Urgent Medical Device Correction:

Affecting all Baxter Novum IQ large volume pumps(LVP)

URGENT MEDICAL DEVICE CORRECTION

July 26, 2023

Figure 1: Rotate Door Open and Shut to confirm Valve movement

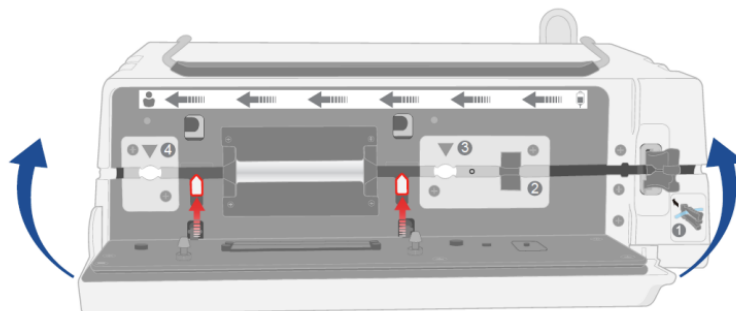
Step 1	Step 2
Confirm pumping mechanism valves (2 white valves when door is open) are not stuck and move up and down. See figure below.	Listen for any atypical sounds coming from the pump.

- Label the pump with a biomedical requisition and bring the pump to your manager

Figure 1: Rotate Door Open and Shut to confirm Valve movement

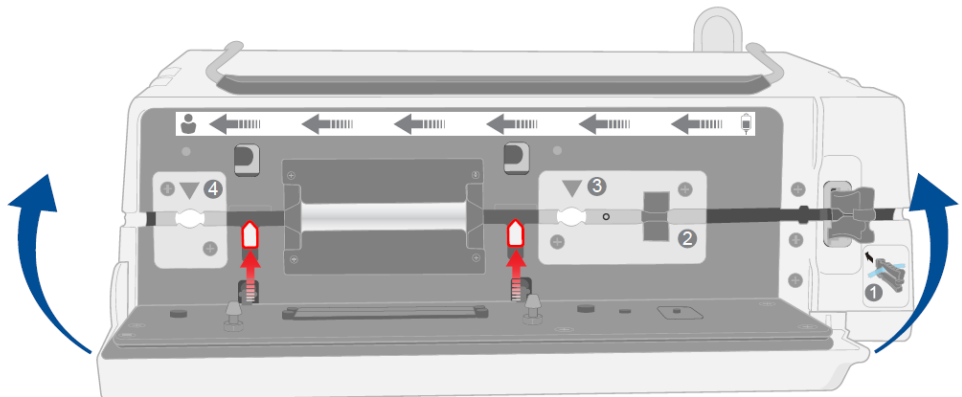
Problem Description Baxter Corporation is issuing an Urgent Medical Device Correction for the Novum IQ large volume pump (LVP) due to the potential for internal screws becoming loose and damaging the pumping mechanism valves. A loose screw within the Novum LVP device that results in damage to the pumping mechanism valves can cause an over infusion.

1. Operators may continue to use the Novum IQ LVP. Prior to use, confirm pumping mechanism valves (outlined in red in Figure 1) are not stuck and move up and down as the Novum IQ LVP door is rotated open and shut. If the mechanism valves are stuck or not moving up and down with the rotation of the door, immediately discontinue the use of the device.
